PREVOST

**SAFETY
RECALL**

Sr12-26

DATE : JULY 2012	SECTION : 06-ELECTRICAL
SUBJECT : POWER CABLE RUBBING PROTECTION

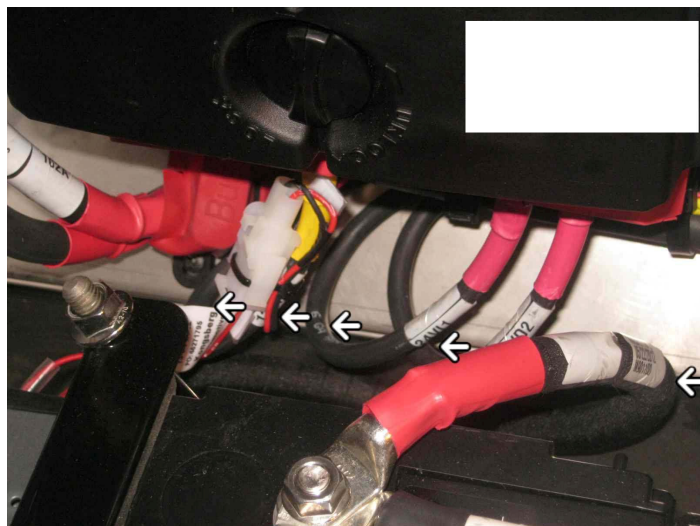
1. In the rear electrical compartment, locate the panel lower edge.

2. No cable should touch this edge even if it is rounded.

Along the complete edge, make sure that no cable touches it.

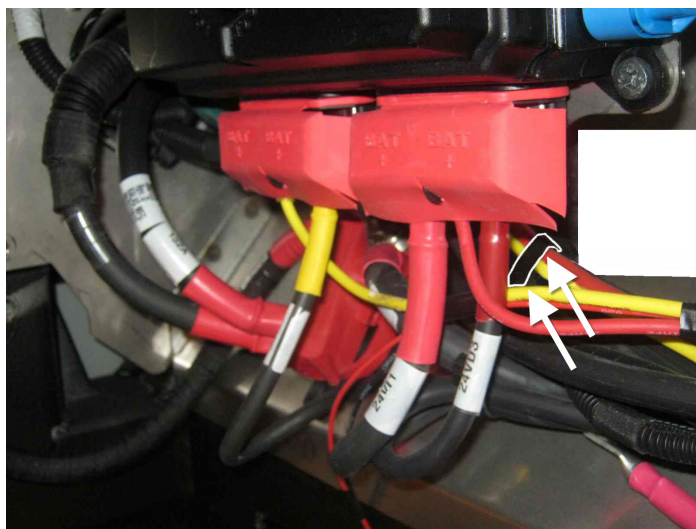
If required, use cable ties to route cables away from the edge.

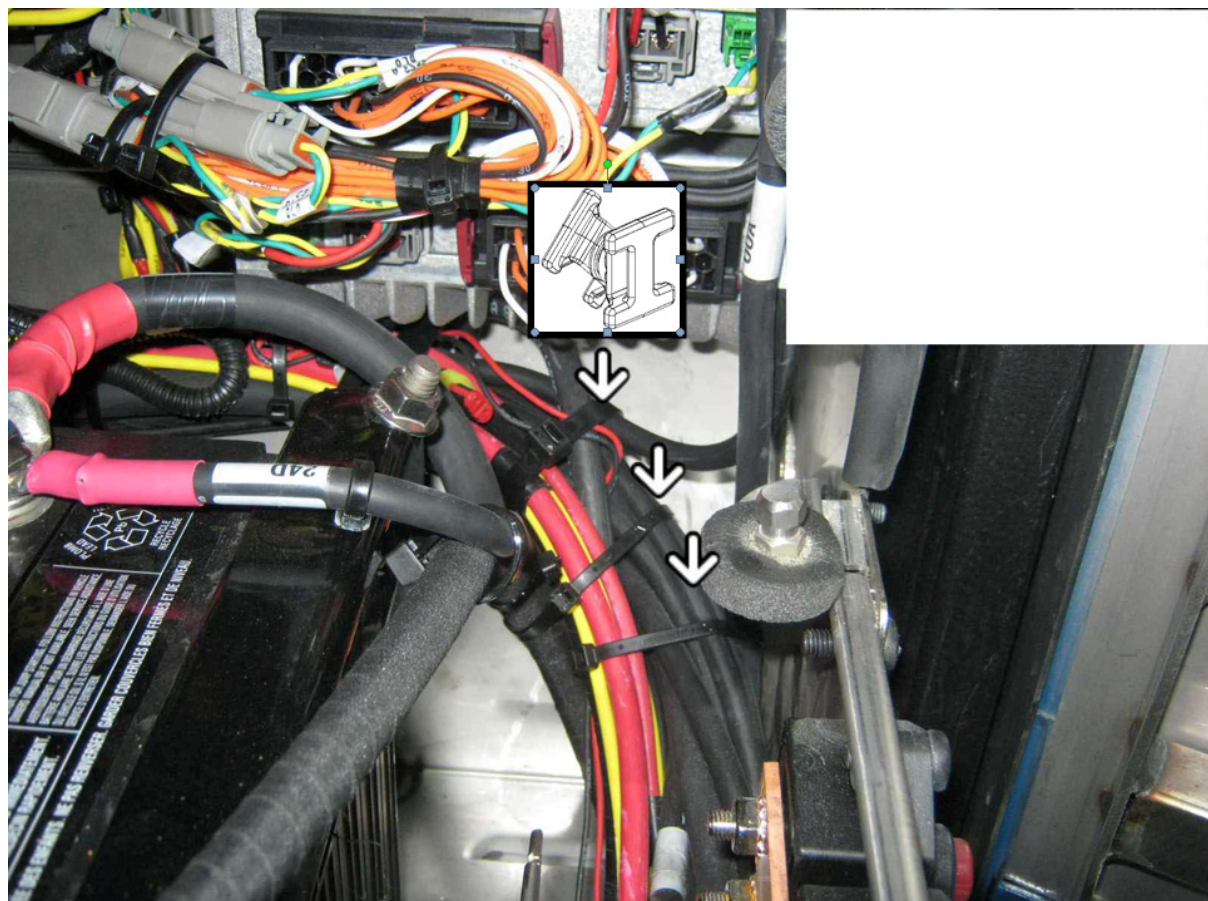
3. Make sure this cable tie is tight (arrows). It is mounted on a cable tie base.

Secure cable bundle at arrow locations making sure to clear the heat sink of the nearby Multiplex module.

Install #504751 double swivel cable tie base with 509491 cable tie on cable bundle.

Base should be installed behind the bundle and bearing on the edge.

Use base as a permanent spacer to maintain a distance from the edge.
